Response to Exhibition of Proposed Residential Buildings at 10, 14 and 14a Stanhope Road, Killara (SSD-81890707)

I object to the proposed development.

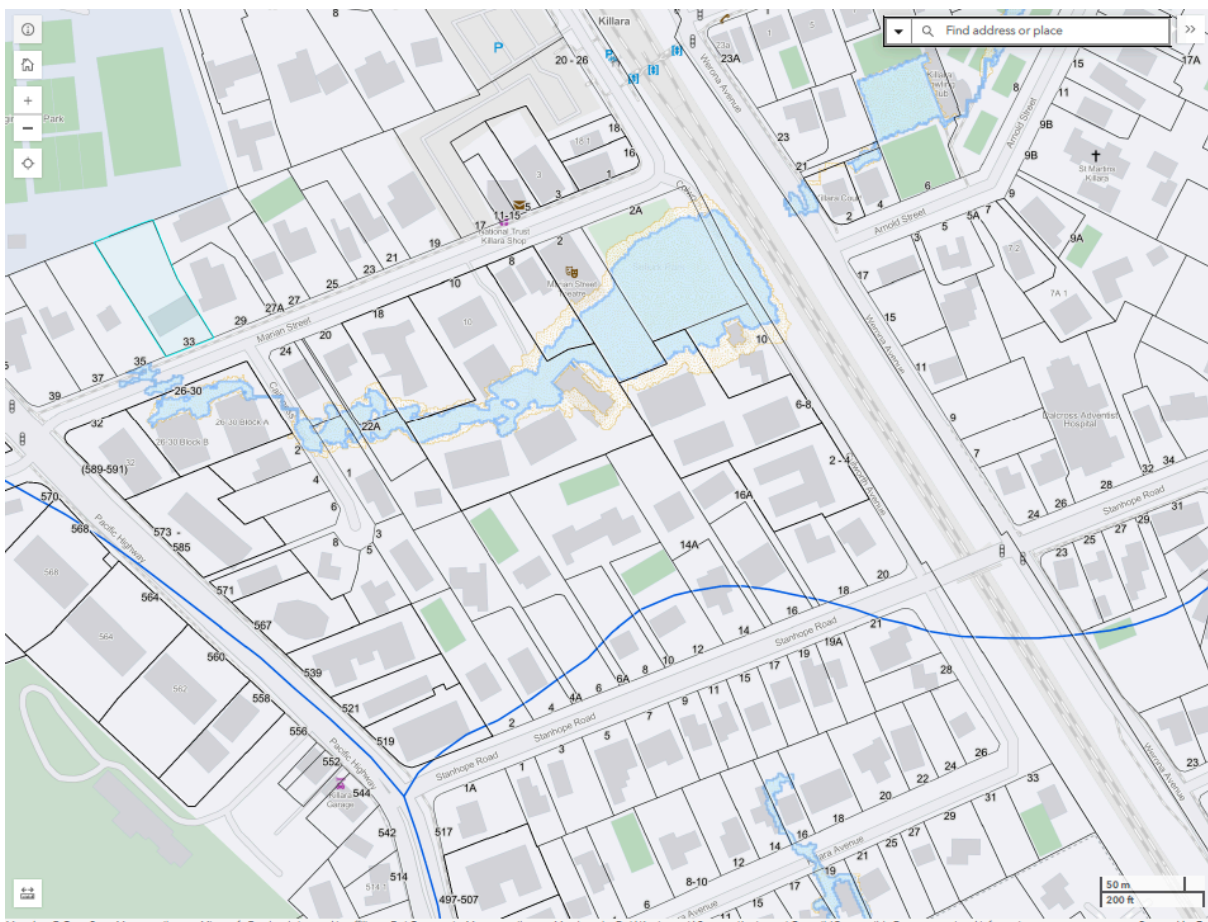
7. There are many other non-compliances with Council’s design requirements, including but not limited to:

- a. Pipes must be outside of the dripline of trees – A5.1(j);
- b. The Detention Tanks/system is located under the private courtyards of Lower Ground 2 residents – A5.1(h);
- c. A5.1(m) states:

m) A spillway or overflow outlet shall be provided in all OSD systems as part of the operation of the system. The overflow shall be designed to cater for total system failure (blockage) in extreme storm events and designed to safely convey all overflows up to the 100 year ARI uncontrolled flow to an adequate downstream drainage system without adverse impact on neighbouring properties.

Figure 54: Section plan – Building B (Source: PBD Architects)

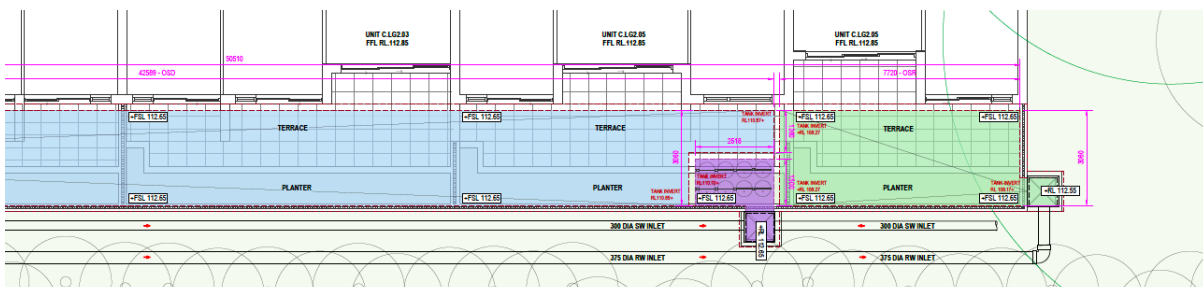
I take issue with Section 2 of the revised architectural plans.

Figure 55: Section Plan - Building C (Source: PBD Architects)

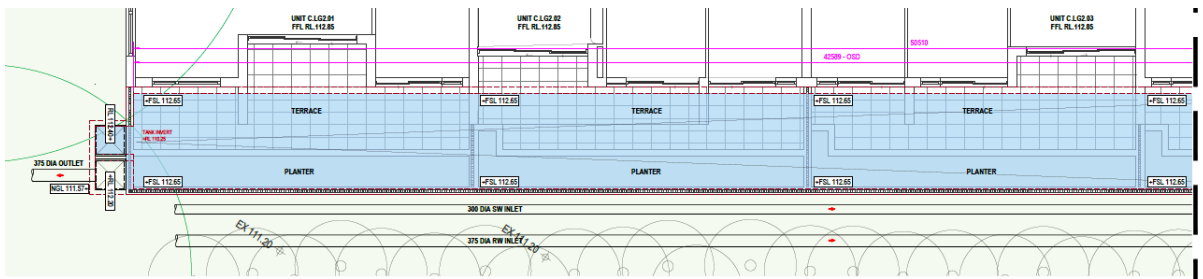
Figure 55: Section Plan – Building C is misleading. It is trimmed to avoid salient reference points and levels.

Section 2 through Building C as shown on drawing DA300 Issue 3 is extracted below:

On this cross section, floor levels and the boundary with 10 Marian Street and its ground level are indicated. The 6m and 9m setbacks are incorrectly positioned and annotated, but it is evident from DA 102 Issue 3 that the edges of the Lower Ground 2 floor apartment terraces are well within the 6m setback, and extend – with the planter boxes to the edge of the Retention / Detention tanks beneath. See Hydracor drawing C6 Issue C.

| DATE | DATE | REVISION | PROJECT |
|--------------------------------------|------|-------------------------------------|---------|
| PROJECT | | Tree Management Plan (Sheet 1/2) | |

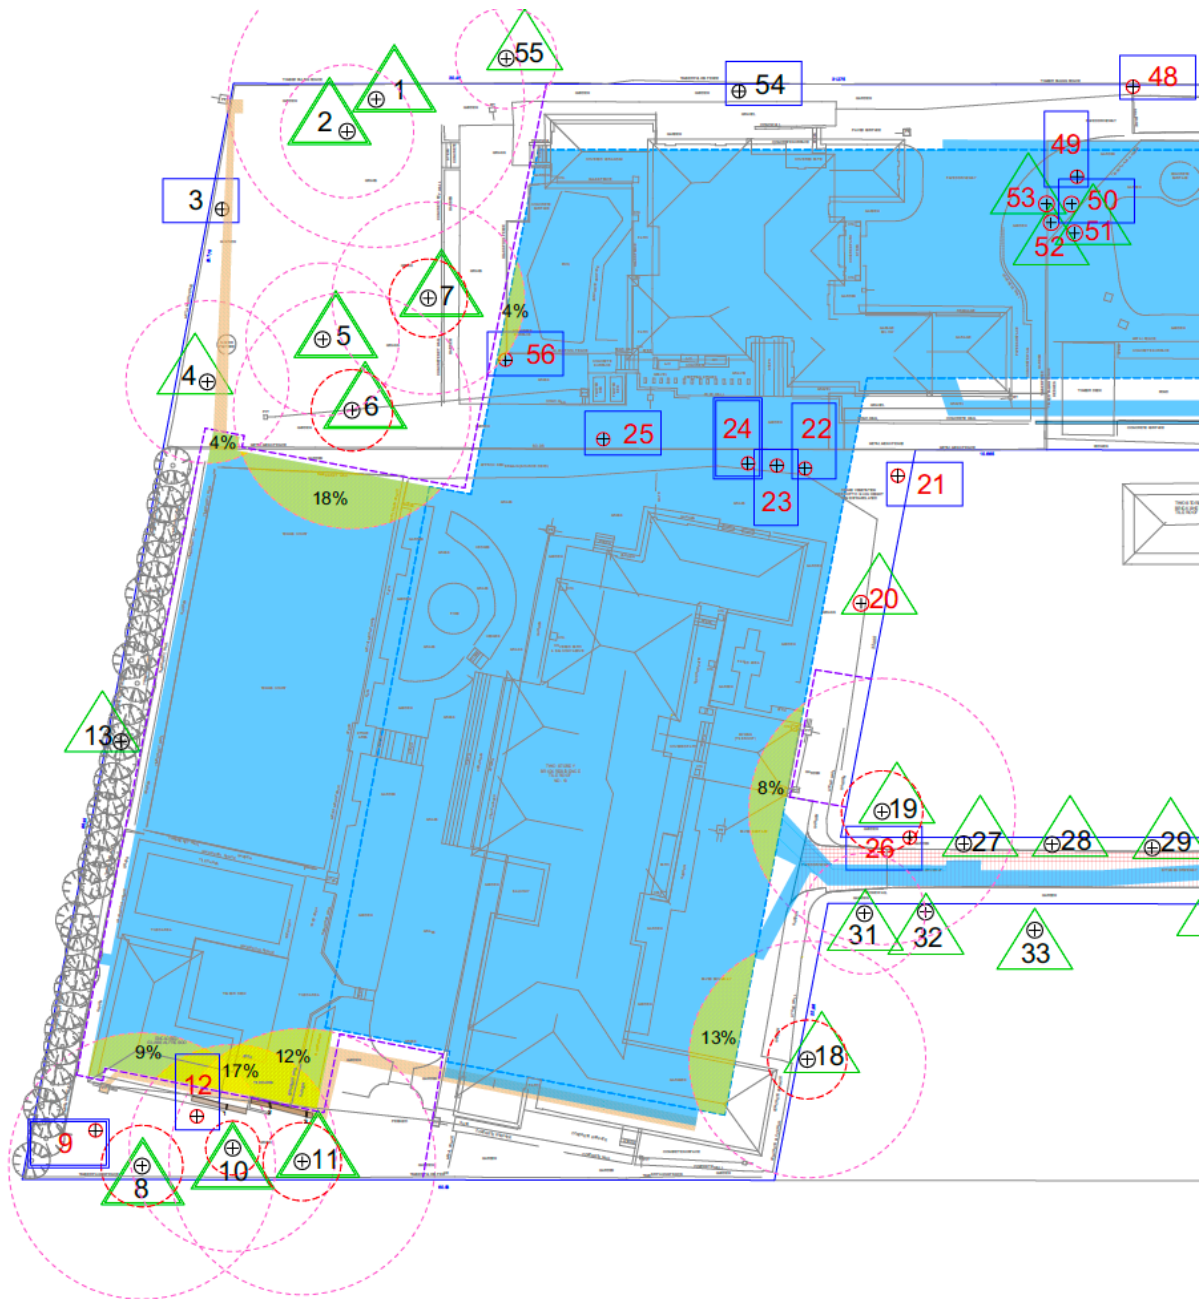
Drawing TMP01 marks the T13 trees as being Category A (ie with a TPZ), but there is no TPZ drafted. We see this as a drafting oversight – otherwise it is a convenient and ominous unexplained exclusion to the benefit the developer.

The preservation of the T13 trees is of concern because according to drawings attached to Appendix 13 – the Stormwater Management Report – the Combined OSD/OSR tank is parallel and in close proximity to the boundary hedging of T13s the tank appears to encroach on the TPZ area.

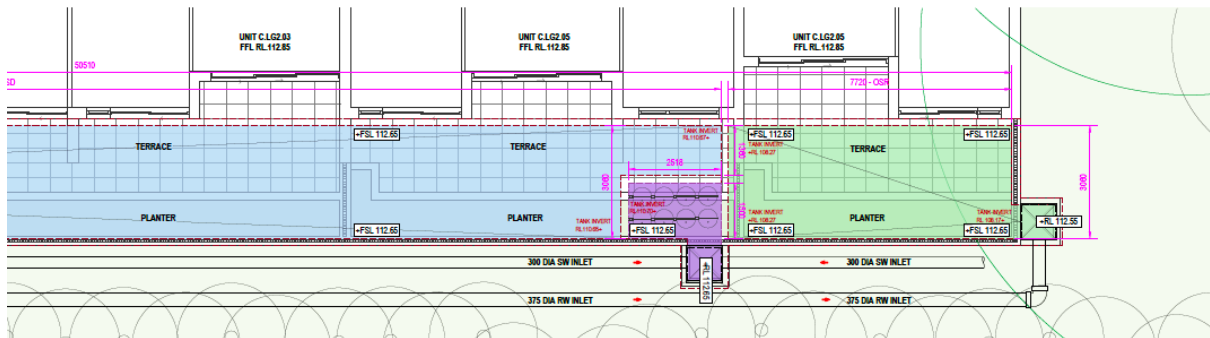
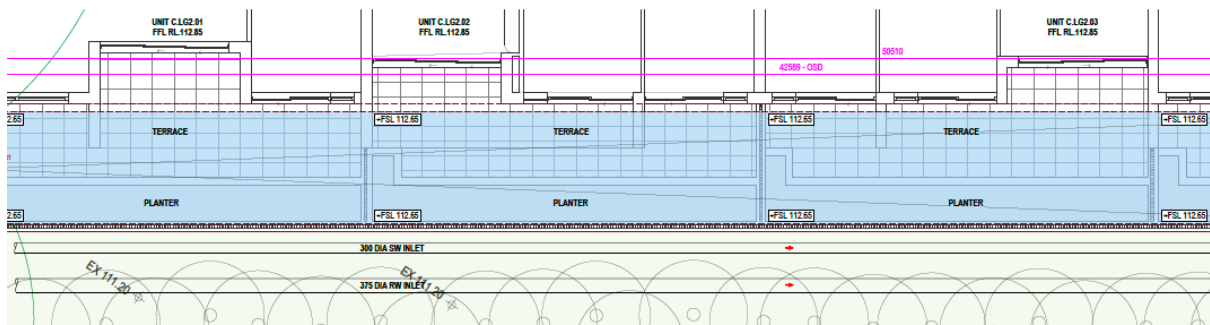
Hydracor drawing 06 Rev C (see below) shows a structure and separated 300 and 375 pipeline within the 6m setback. No dimensions or TPZ is shown and no cross sections with the boundary and accurate tree trunk line is drafted.

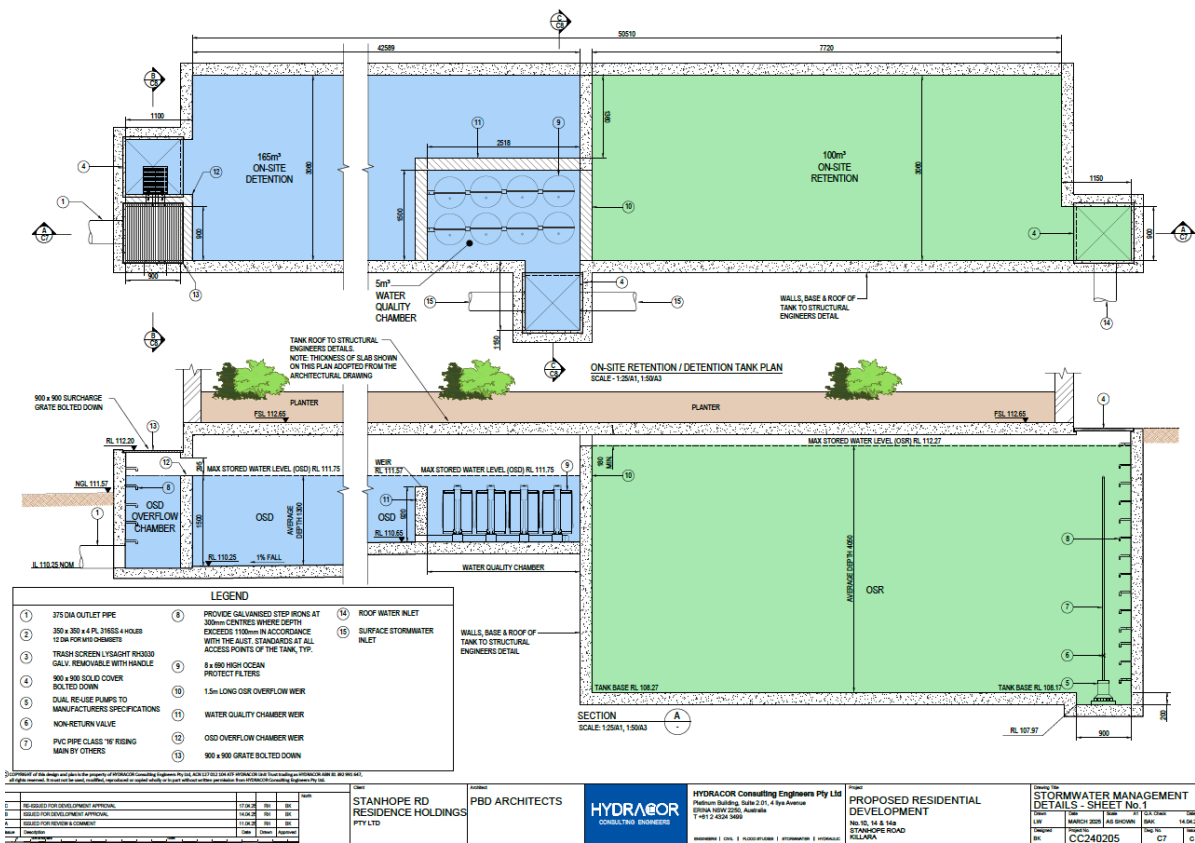
Further, the sections shown on drawing C7 Rev C, (see below) indicate the OSR tank having an excavated level of 107.77 (assuming 200mm thick base slab). Therefore, there is an excavation depth in the order of at least 4metres at the 6m setback boundary to the northwest boundary with 10 Marian Street. Given that the T13 trees are well within the 6m setback then it is hard to see how their TPZs and viability will not be affected. More details, construction methodology and dimensions cross sections are needed.

As referenced elsewhere, we would query whether placing Detention tanks under the private dwelling's external terraces is permitted by council regulations.
